LOMPOC UNIFIED SCHOOL DISTRICT

LOS BERROS ELEMENTARY SCHOOL

BUILDING 'E' WINDOWS

① Building 'E' East Elevation
SCALE: 1/4"= 1'-0"

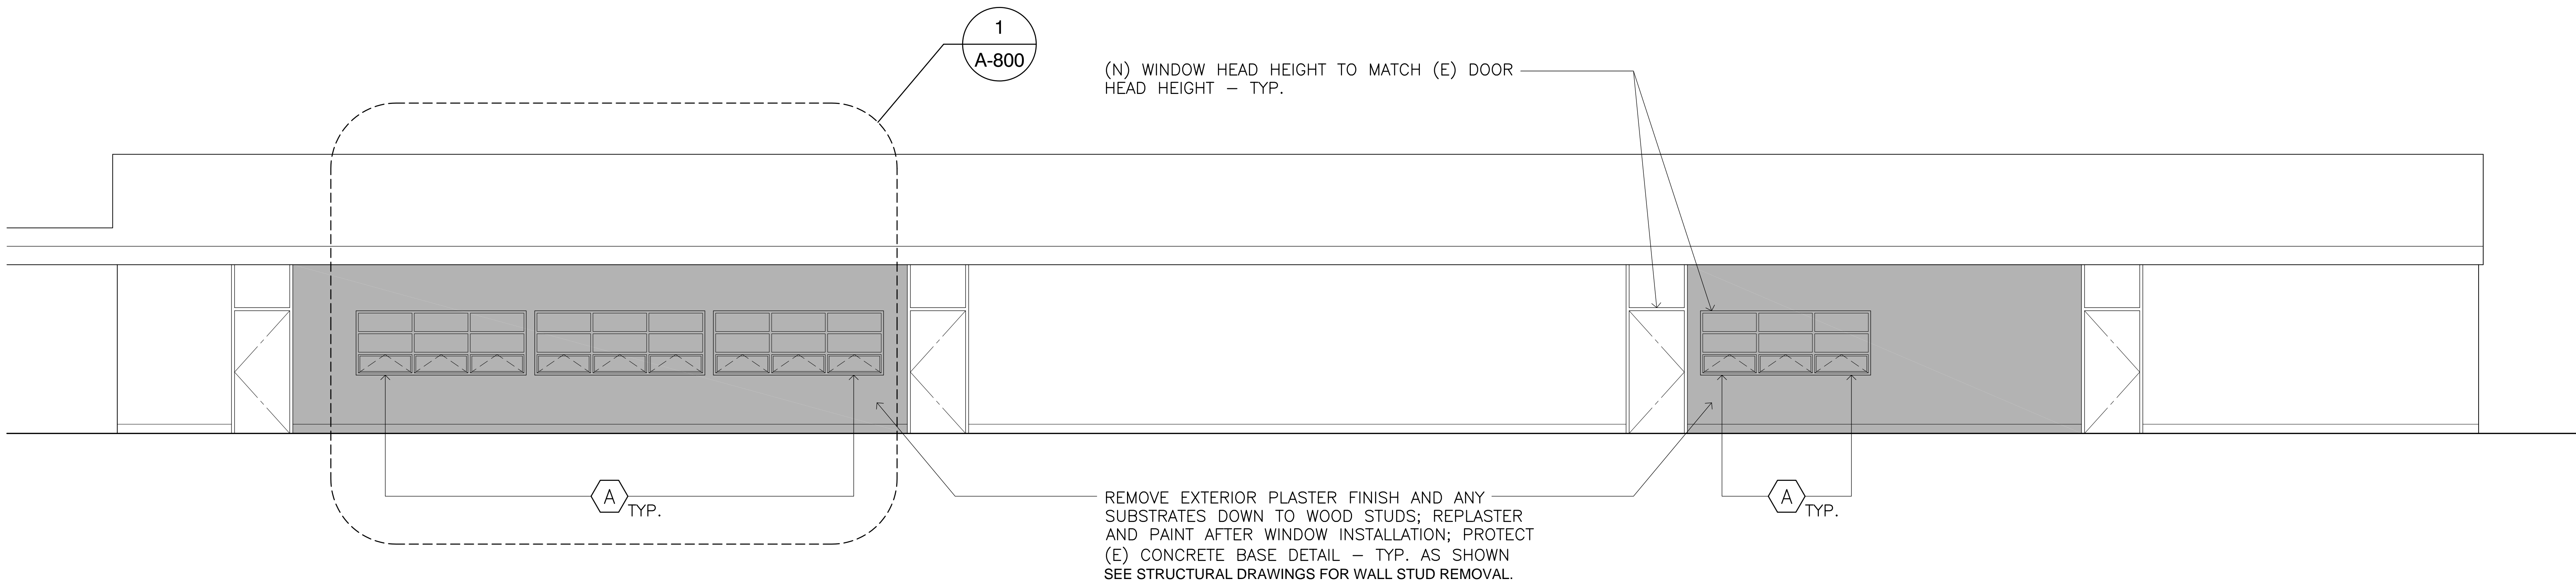
Comment from V1:			
▼ A	Any (e) shear wall to be removed for the (n) windows? Please provide demo plan or provide existing DSA approved drawings.	A-301 BUILDING 'E' EXTERIOR ELEVATIONS	5 Hani Freudenberger DSA Structural
↳	No shear walls to be removed. Existing drawings provided for reference.	A-301 BUILDING 'E' EXTERIOR ELEVATIONS	5 jonathanl
How is the extent of demo indicated? Based on structural drawing, studs are cut, steel headers and columns are added in order to create the new openings in the existing walls. This, along with any other demolitions, should be shown in the demo plan			
2/24 this comment remains open, pending additional notes on structural plan to clarify extent to demo

WINDOW TYPES

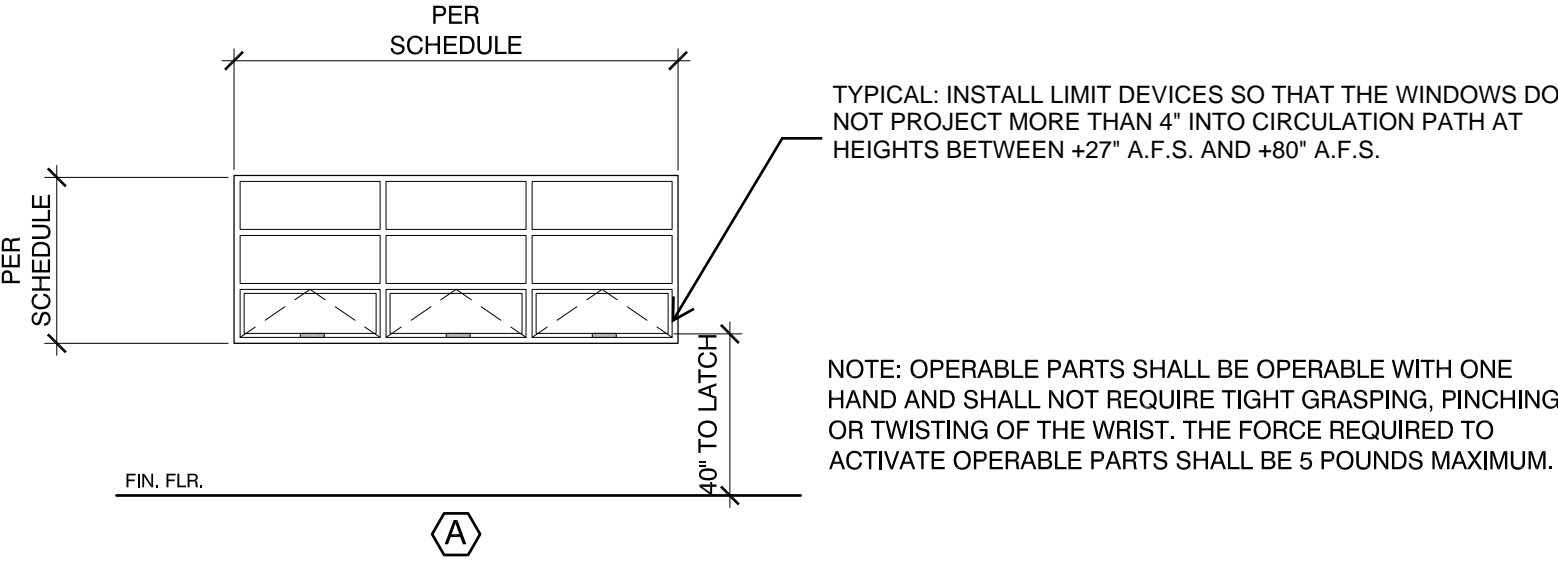
This note needs to be added to address the last remaining comment on DWG V1

Note to Contractor:

The California Energy Code Section 10-103 requires Acceptance Testing on all newly installed lighting controls, mechanical systems, envelopes, and process equipment after installation and before project completion. An Acceptance Test is a functional performance test to help ensure that newly installed equipment is operating and in compliance with the Energy Code.

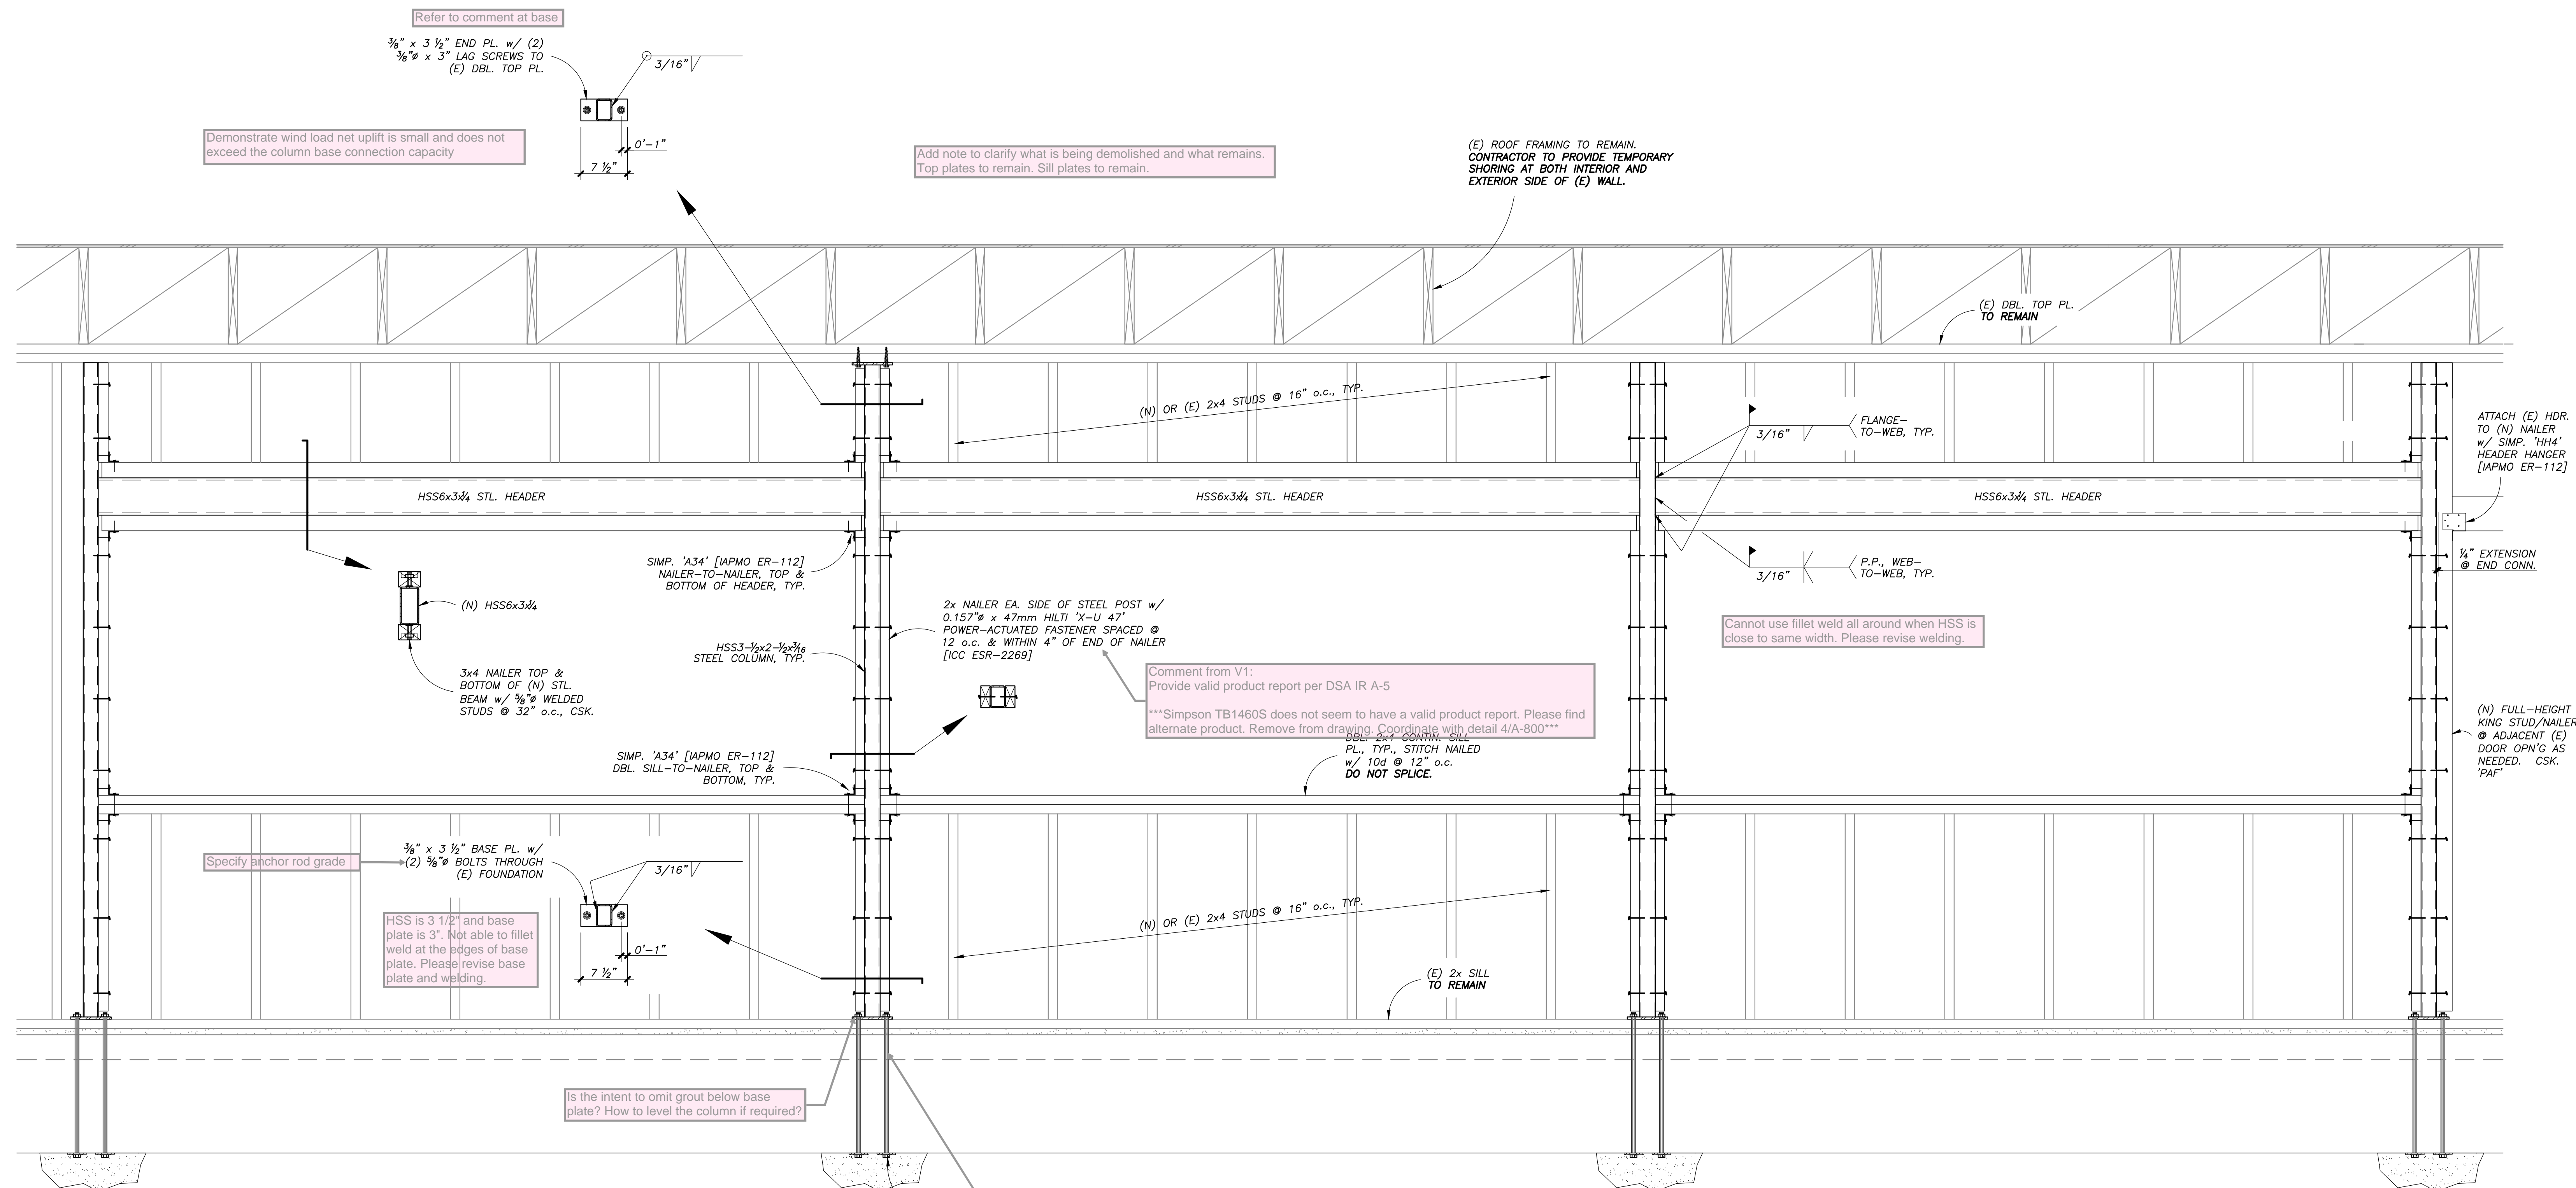
The product report for Simpson Titen HD concrete screws is valid for $f'_c = 2500$ psi or greater. Per existing drawings provided, the concrete f'_c is 2000psi, which is not sufficient for any valid post-installed anchors currently.

Core tests can be used to verify the strength of (e) concrete. Prior to the DSA approval, please provide the following:

(a) A written test procedure, map indicating locations of sample, and acceptance criteria by a DSA approved testing laboratory. Suggest to take some samples from slab which will be removed due to proposed plumbing work. Provide enough samples so that the coefficient of variation does not exceed 20%.

(b) Items listed on (a) must be reviewed and approved by both SEOR and DSA.

(c) After the approval of test procedure, all required tests shall be performed, and a test report shall be reviewed by SEOR.

(d) SEOR shall submit an acceptance letter of test report and specify a value on the drawing.

Per existing drawings provided, maximum allowable soil pressure is 1000 psf. Please provide justification that the soil pressure below the footing at new steel columns do not exceed the allowable.

TYPICAL FTG.

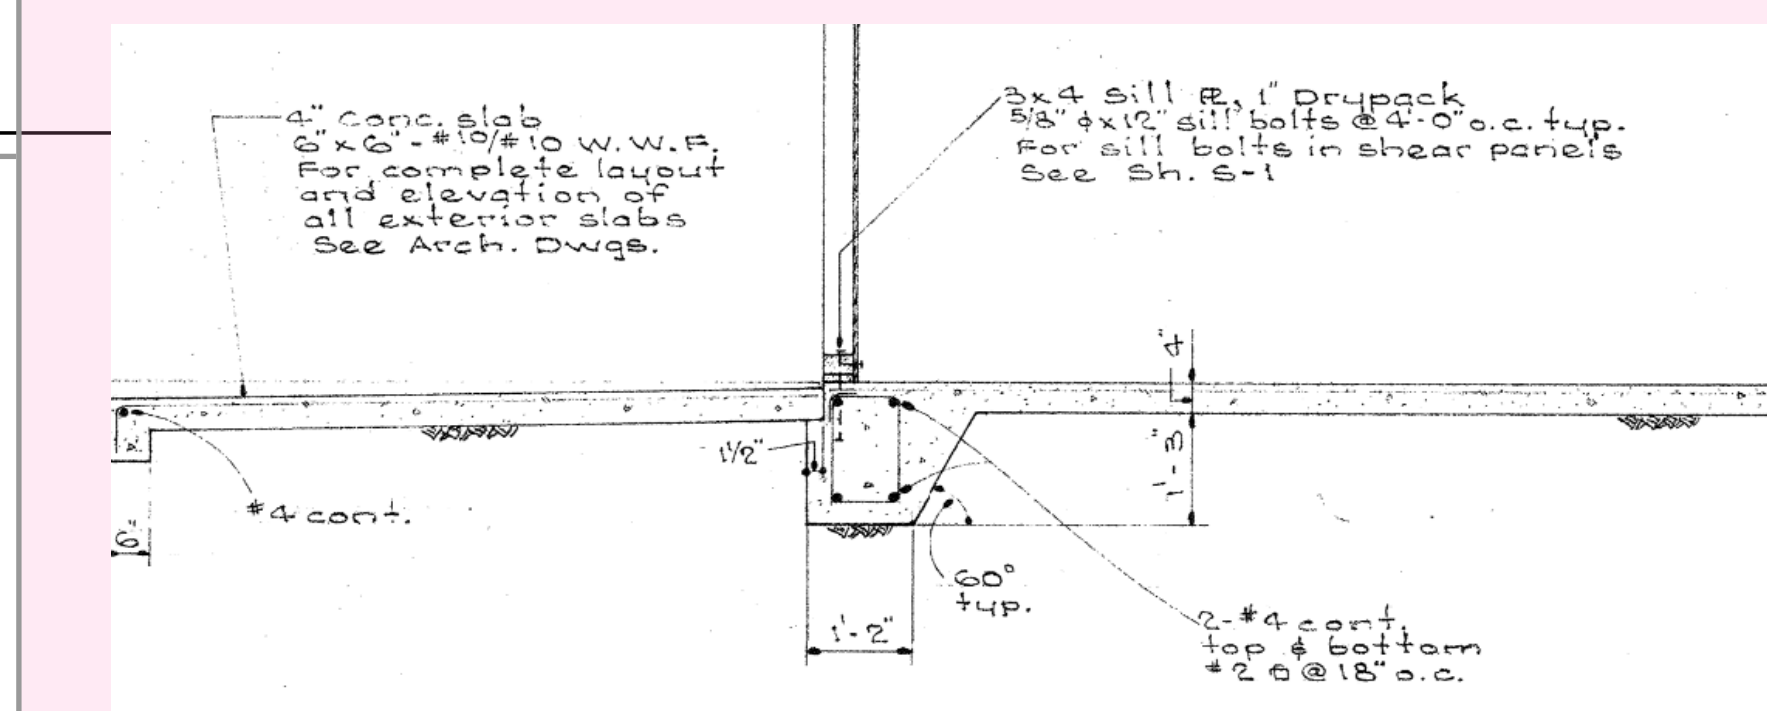
Comment from V1:		
Anchoring to (e) concrete curb? If that is the case, please provide (e) concrete curb width, height, and f'_c . Verify the post installed anchors have sufficient edge distance, and the (e) concrete curb has sufficient capacity.	S-301 STRUCTURAL DETAILS	11 Hani Freudenberger DSA Structural
There is no curb. The anchors attach directly to the top of the concrete footing which has been poured monolithically with the slab-on-grade. The 3.25" edge distance has been verified, and is shown on page 28 of the structural calculations.	S-301 STRUCTURAL DETAILS	11 GStork

Detail from existing drawing does not seem to indicate 3.25" edge distance. Please provide additional explanation/justification
